Application Number	PT8GC231
Applicant Name	Galway County Council
Development Address	Eanach Dhúin/ Annaghdown Co. Galway

Application Number	PT8GC231
Applicant Name	Galway County Council
Development Address	Eanach Dhúin/ Annaghdown Co. Galway

I Robert Mulryan live opposite the proposed graveyard. I think there are several improvements that could be made to the graveyard design such as putting the entrance on the main road with a normal car park, buying the entire field and connecting the new & old graveyards by footpath for safety.

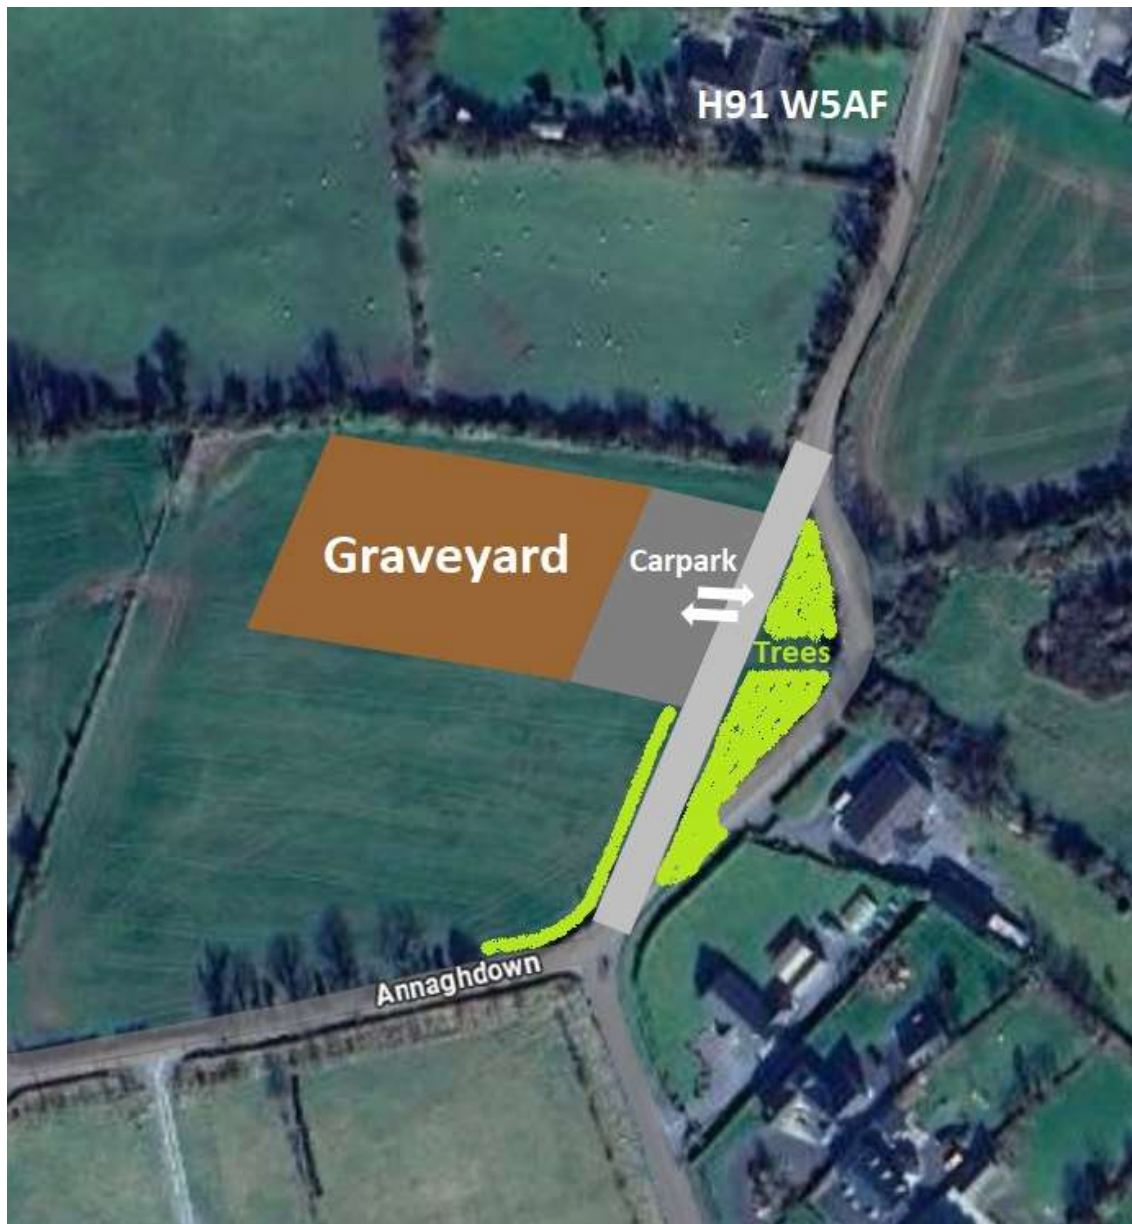
1. The entrance to the graveyard should be on the main road

The proposed design has only 1 way in and 1 way out and will be a bottleneck during burials. Having an entrance on the main road will allow traffic to get away quickly in 2 directions like the current graveyard.

- Normal car park
A normal car park on the main road would be far easier for people attending burials compared to the car parking being proposed.
- Graveyard should have pride of place
The graveyard should have pride of place on the main road like the current graveyard instead of being hidden away up a cul-de-sac in the corner of a field behind a hedge.

- This design would allow the graveyard to be fronted by a nice stone wall (like the new Ballinrobe graveyard) instead of the concrete fencing & farm gates being proposed along the access road.

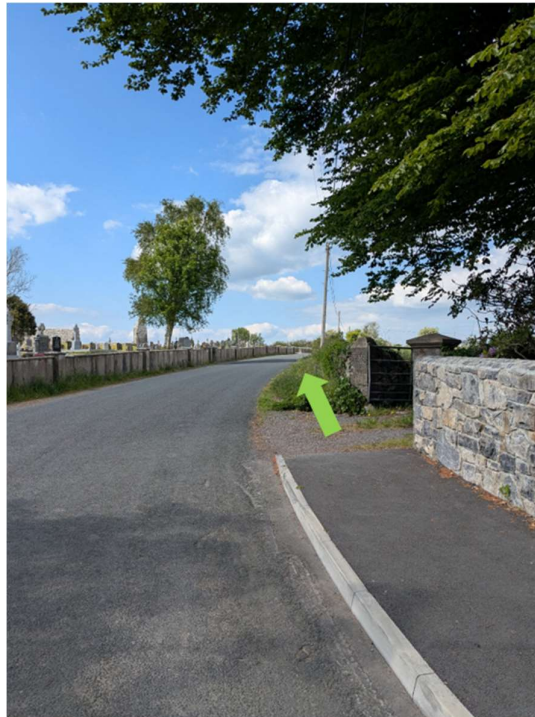
2. The council must buy the whole field

- Proposed graveyard could be full again in 30 years
The proposed graveyard has 315 plots and the parish has 10 bereavements per year. Therefore, the proposed graveyard could be full again in just over 30 years (probably much sooner as the graveyard is not restricted to people with a link to the area). It took around 10 years to find this field, will it be possible to find another field in 30 years?

- To have a graveyard for the next 100 years
The council must buy the entire field to provide a graveyard for the next 100 years. Per the councils burial ground policy, the council pays agricultural prices for land (approx. €10,000/acre). There is about 3 acres remaining in the field. The €30,000 needed to buy the rest of the field could be easily funded by the presale of around 40 double plots. (€726 each). This opportunity to buy the whole field must be taken to future proof the graveyard needs of the area.

- Normal car park
A normal car park will be possible with enough spaces to get all cars attending burials in off surrounding roads.
- Space for all graves to face east to the rising sun like the current graveyard instead of the proposed half facing east & half facing west.

4. How do cars parked on the access road leave after burials?

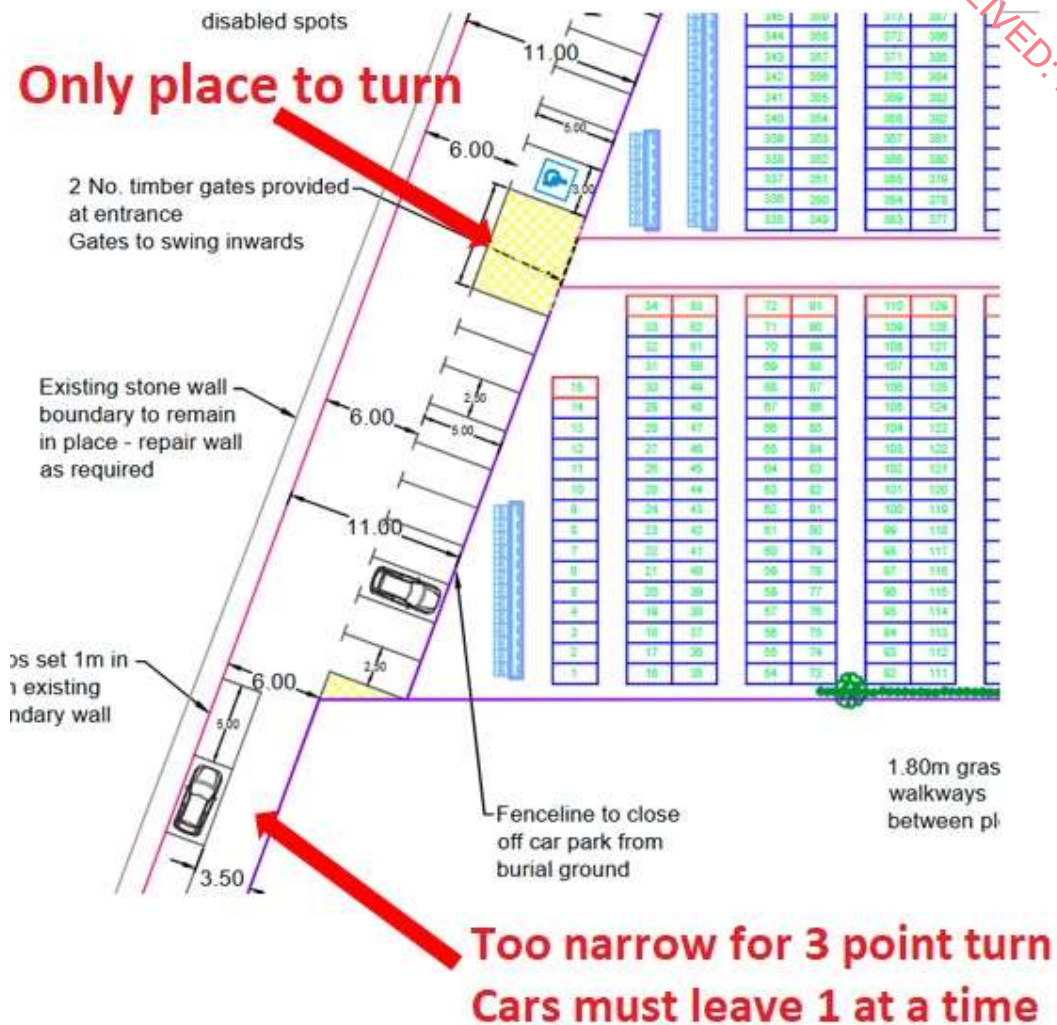
- After burials, the cars parked on the access road will leave before the family cars parked at the graveyard.
- The access road is too narrow to do a 3-point turn.
- Cars parked on the access road must drive up to the graveyard gate to turn.
- 1 car leaving blocks the access road so cars must leave 1 at a time slowing everything down.
- People looking for a discreet and efficient get away after a burial will naturally park on surrounding roads & outside houses which creates unnecessary health & safety risks.
- A normal car park on the main road cuts out all these unnecessary problems.
